C0200-04  
10 CFR 50.90

Donald C. Cook Nuclear Plant Units 1 and 2  
LICENSE AMENDMENT REQUEST  
MODIFICATIONS TO AUXILIARY FEEDWATER PUMP ROOM COOLING

### DESCRIPTION AND SAFETY ANALYSIS FOR THE PROPOSED CHANGES

Figure 2: Proposed Auxiliary Feedwater Pump Room Cooling Configuration

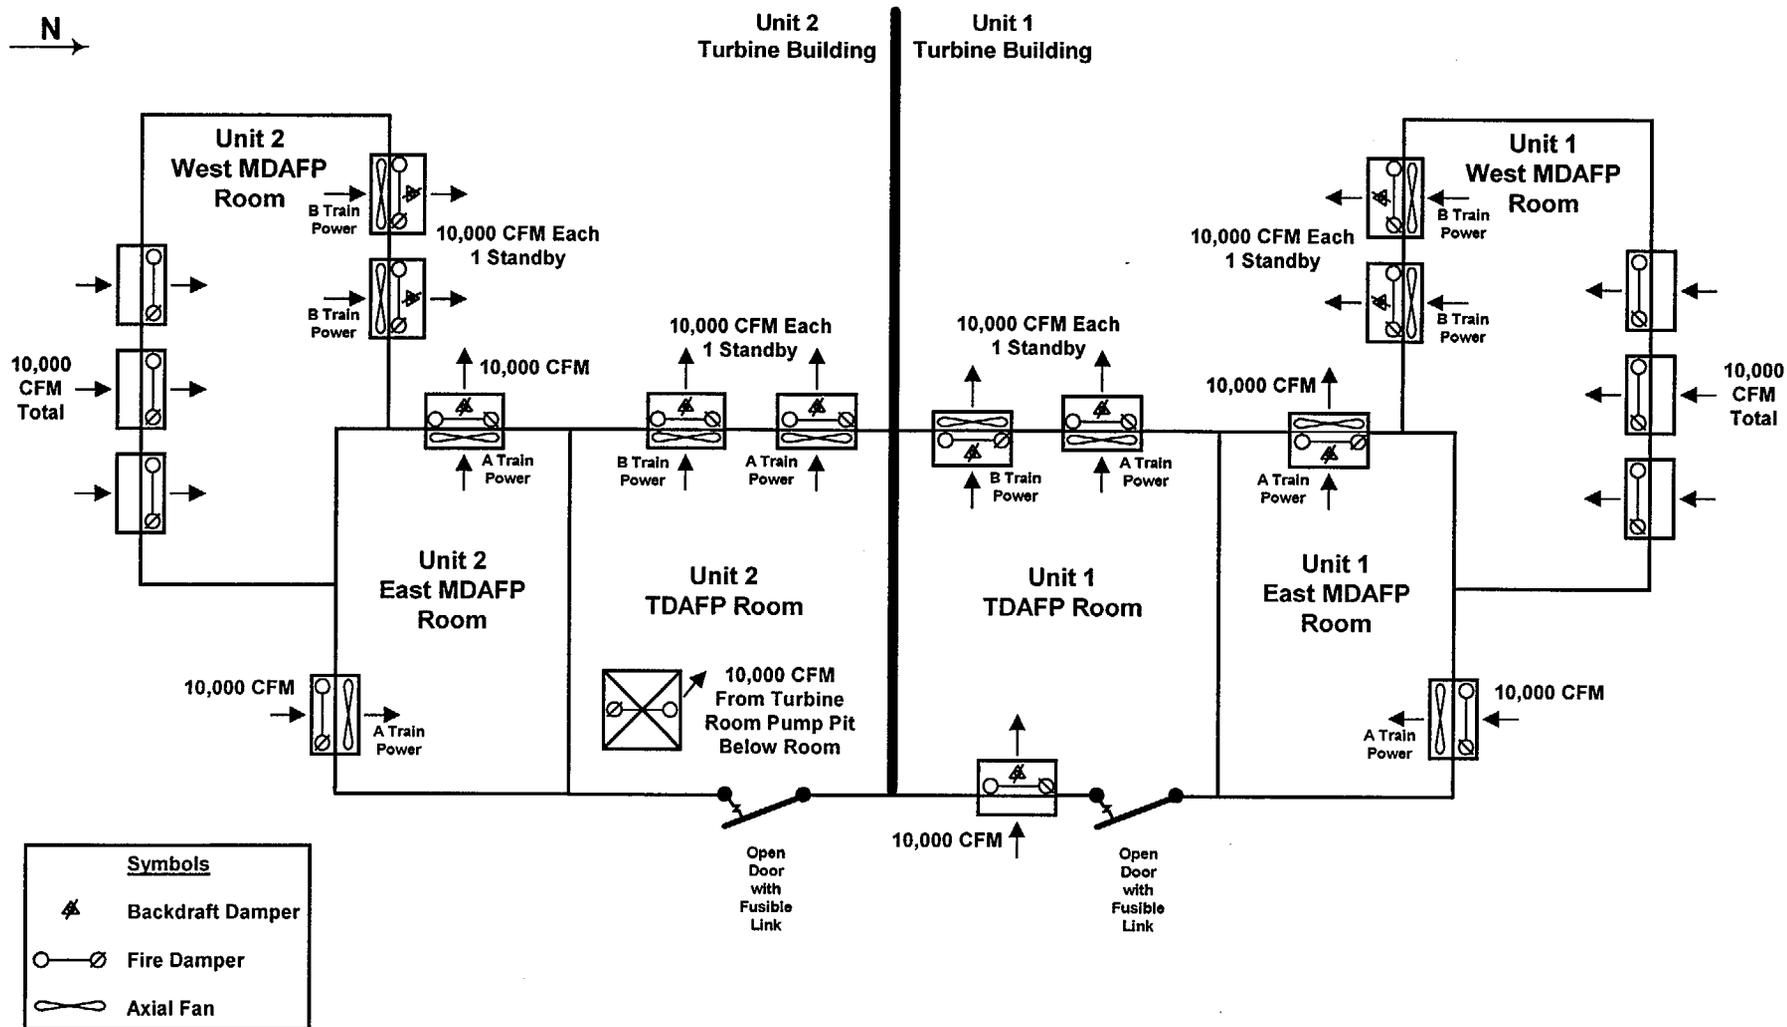
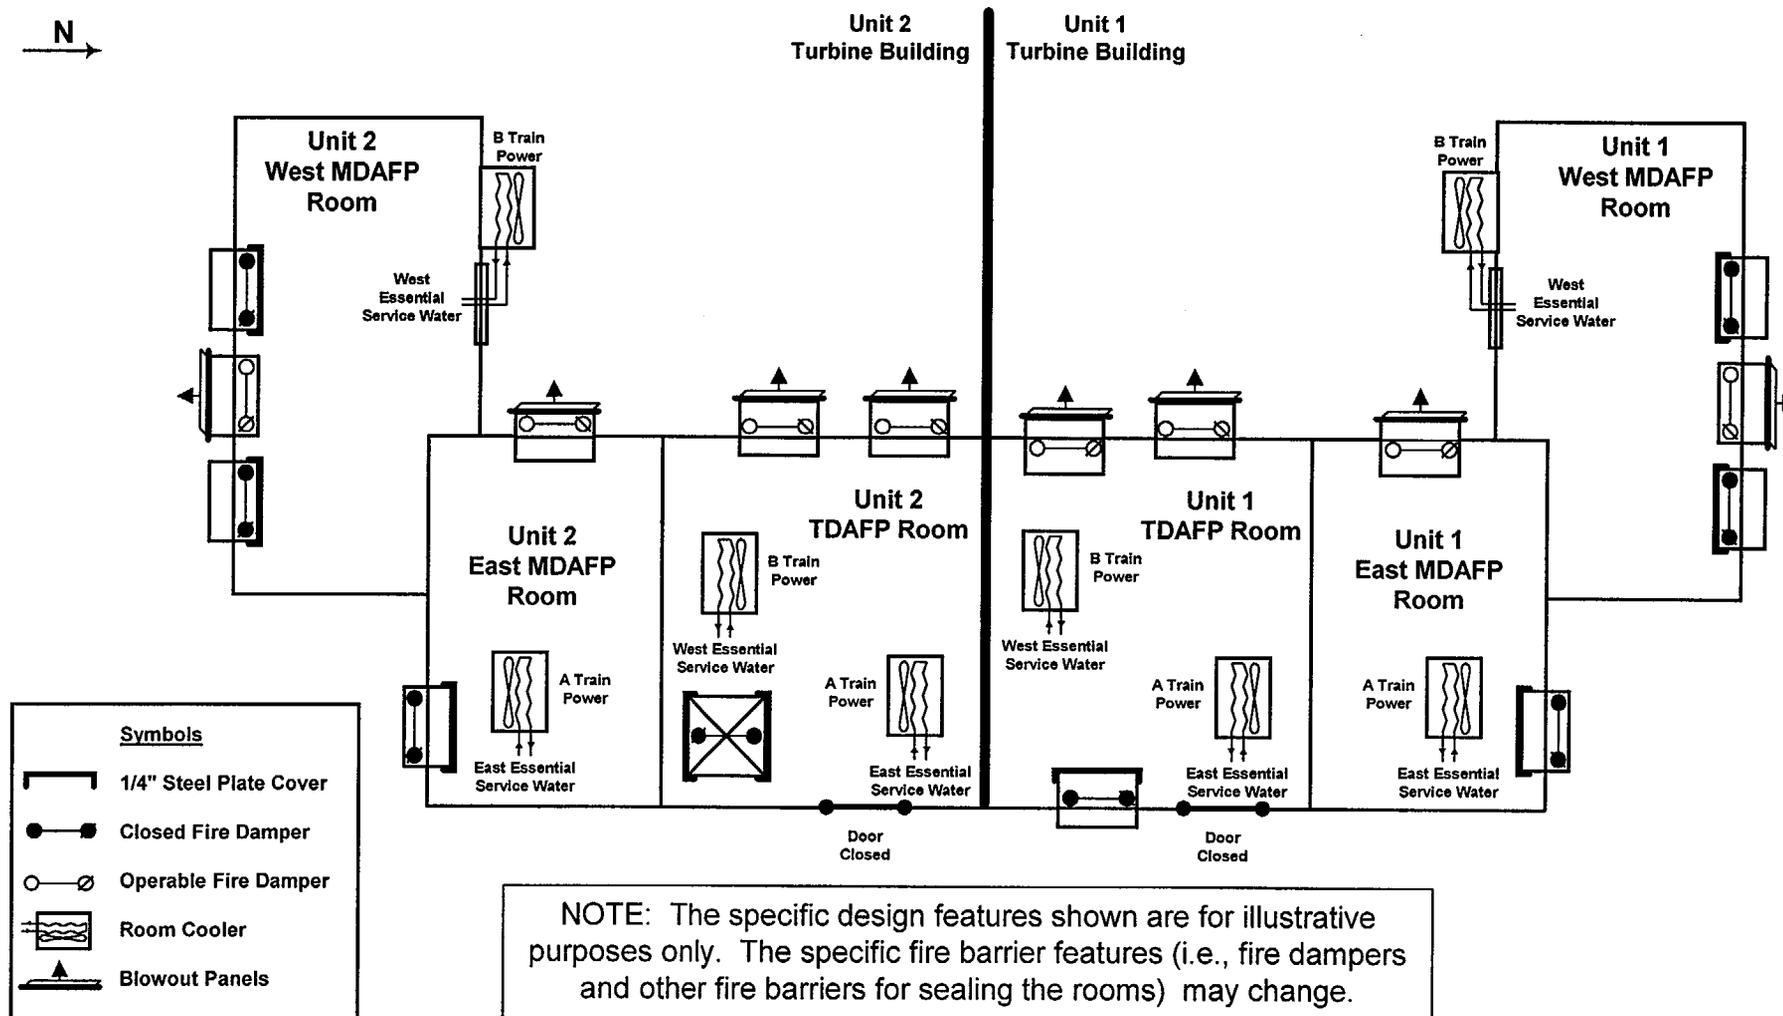
For each unit, the existing east MDAFP room ventilation system exhaust fan and supply fan, including motors, will be removed. The exhaust fan backdraft damper will be removed. One fire damper will be closed. The opening created by removal of the fan will be sealed by a steel plate from inside of the room to ensure a fire and HELB barrier is maintained. A blowout panel will be added to the other opening to allow for depressurization of the room during a tornado event. The door to the east MDAFP room will remain closed as a fire and HELB barrier.

A new room cooler and replacement room thermostat will be installed. The new cooler will be interlocked to operate when actuated by the room thermostat. This thermostat will be set to maintain the room less than the current design temperature. The new room cooler will be designed to maintain the temperature of the east MDAFP room below the current room equipment design temperatures when the east MDAFP is in operation. ESW will be provided to the new room cooler from the respective unit's east ESW train.

For each unit, the existing west MDAFP room ventilation system exhaust fans, motors, backdraft dampers, and fire dampers will be removed. The door to the west MDAFP room will remain closed as a fire and HELB barrier. Two of the three west MDAFP air intake fire dampers will be closed and the openings sealed by a steel plate from inside of the room to ensure a fire and

HELB barrier is maintained. A blowout panel will be added to the third opening to allow for depressurization of the room during a tornado event.

A new room cooler will be installed in one of the openings created by removal of an exhaust fan. The new room cooler will protrude through the opening and include an enclosure to protect the room cooler from internally and externally generated missiles, the maximum HELB environment, and to serve as a three-hour fire barrier. The openings in the wall around the enclosure will be sealed to provide a three-hour fire barrier and HELB barrier. A replacement room thermostat will be installed. The new cooler will be interlocked to operate when actuated by the room thermostat. This thermostat will be set to maintain the room less than the current design temperature. The new room cooler is designed to maintain the temperature of the west MDAFP room below the current room equipment design temperatures when the west MDAFP is in operation. ESW will be provided to the new room cooler from the respective unit's west ESW train.

For each unit, the existing TDAFP room ventilation system exhaust fans and backdraft dampers will be removed. The fire damper in the air intake for the Unit 1 room located in the wall and the fire damper in the air intake for the Unit 2 room located in the floor will be closed and the openings sealed by a steel plate from inside of the room to ensure a fire and HELB barrier is maintained. The existing door to the TDAFP room will be closed as a fire and HELB barrier with the thermal fusible link mechanism disabled. The fire dampers for the exhaust fans will remain operable and functional as a fire barrier with the thermal fusible links replaced to increase the temperature settings from 160°F to 325°F. This will not cause the damper to actuate in a HELB environment but will ensure protection in the case of a fire. Blowout panels will be installed on the outside of the two existing exhaust openings. These blowout panels will prevent structural failure of the TDAFP rooms if the 4-inch steam supply piping were to break while providing a HELB barrier for HELB events occurring in the turbine buildings.

Two new room coolers and associated replacement room thermostats will be installed in the room. The new coolers will be controlled by dedicated thermostats. These thermostats will be set to maintain the room within current design temperature. The new room coolers are designed to maintain the temperature of the TDAFP room below current equipment design temperature limits independently when the TDAFP is in operation. ESW will be provided to the new room coolers from the respective unit's east and west ESW trains.

The new design will ensure that the maximum TDAFP room temperature following an SBO will not exceed 133.6°F. This is consistent with the current SBO analysis and will ensure that the TDAFP is available for the 4-hour SBO coping period.
